## **REMARKS**:

The above-identified patent application has been amended and Applicants respectfully request the Examiner to reconsider and again examine the claims as amended.

Claims 1 to 4 are pending in the application. Claims 1 and 2 are rejected. Claim 1 is amended herein. Claims 3 and 4 were withdrawn.

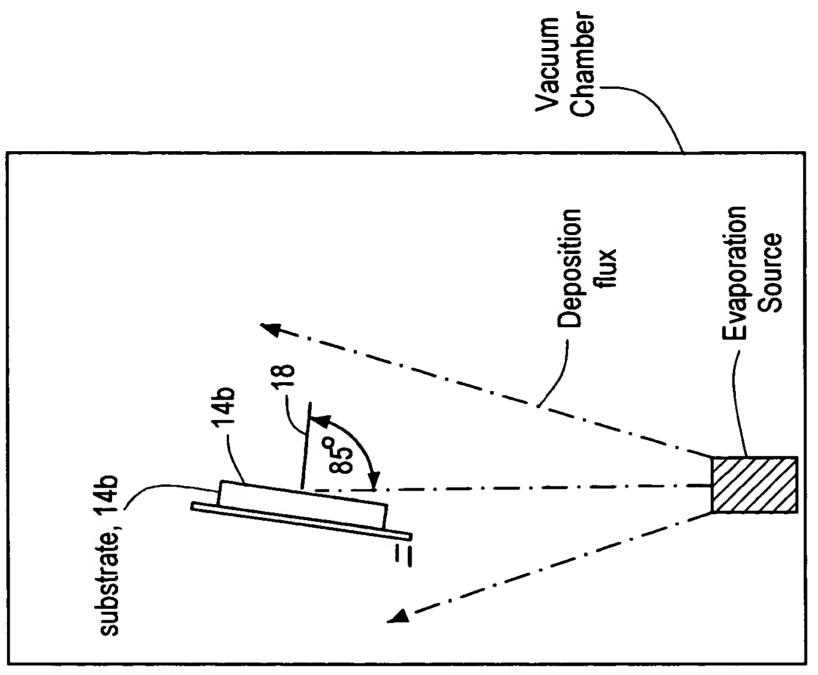
In FIG. 1, add the numeral 12 and associated lead line and extend the lead lines associated with numerals 14a and 14b as shown;
